## PROPOSED AMENDMENT DRAWING

NMA DESIGN REPORT

NO.1 TRITON SQUARE

246868-A\_A-XX-XX-DR-AX-30530 South Elevation

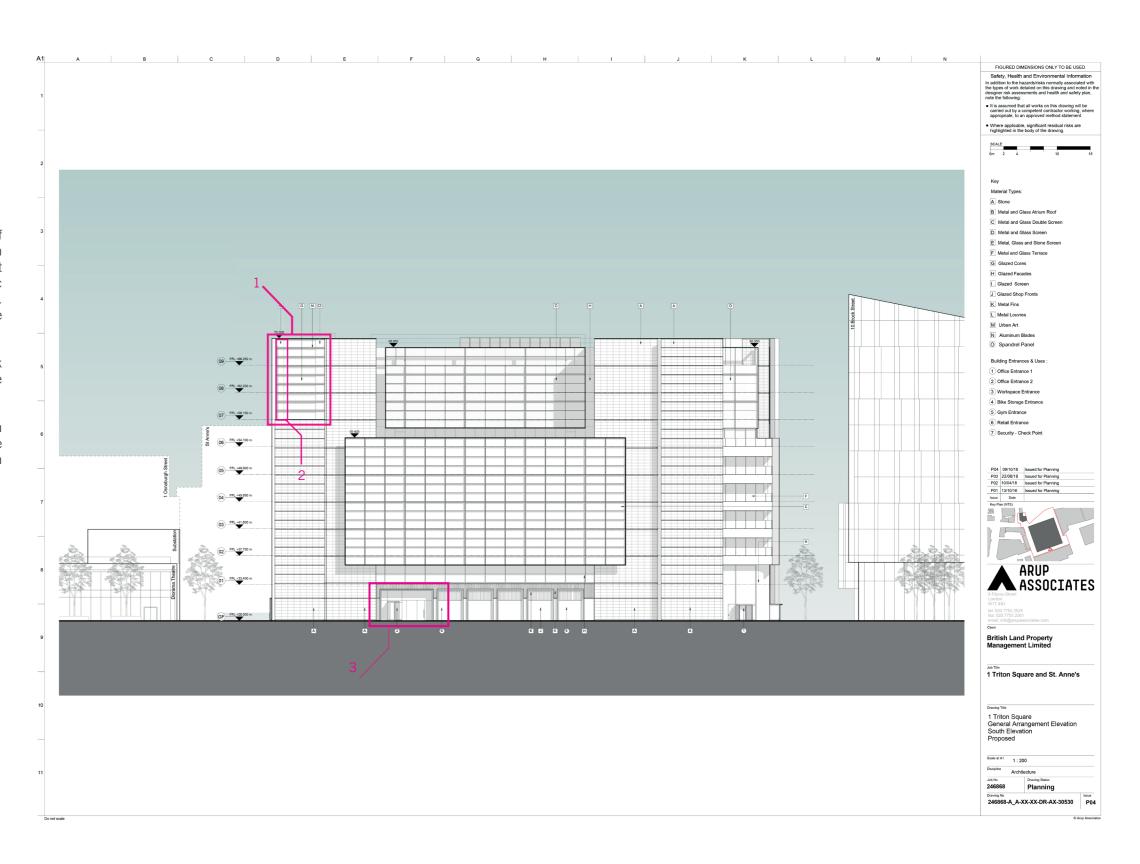
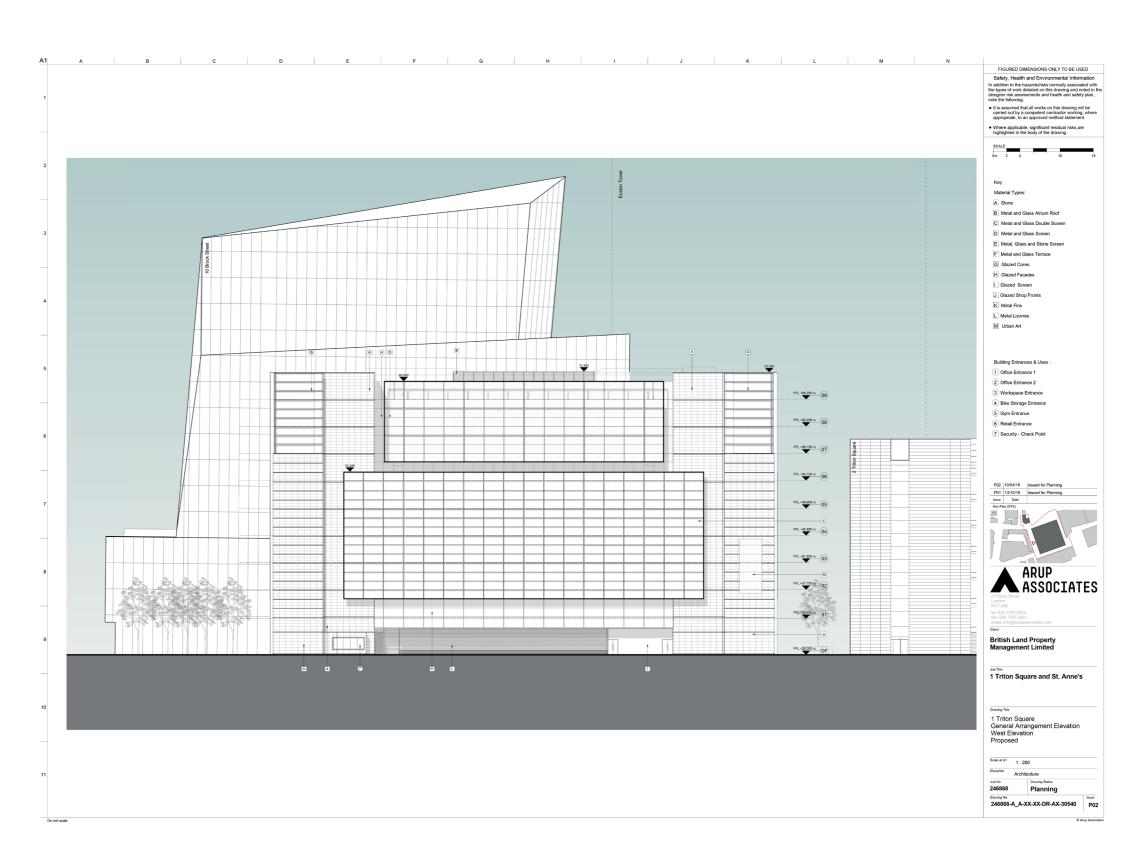
- (1) A change in materials to the transoms at the top of cores from stone to anodised aluminium is proposed. Each transom is 7m wide and following design development deemed structurally unachievable given weight and aesthetic requirement for unobstructed panoramic glazing panels. This affects 6 of the 10 transoms at the top of each core. The remaining 4 are natural anodised aluminium as approved.
- (2) Introduction of additional mullion to separate back painted glass spandrel panel from vision glazing note spandrel panel hides steel column behind.
- (3) The depth of Core 2 entrance has increased from 300mm to 1000mm to enhance visibility as a second office entrance. Proportions and consistency of design approach maintained.
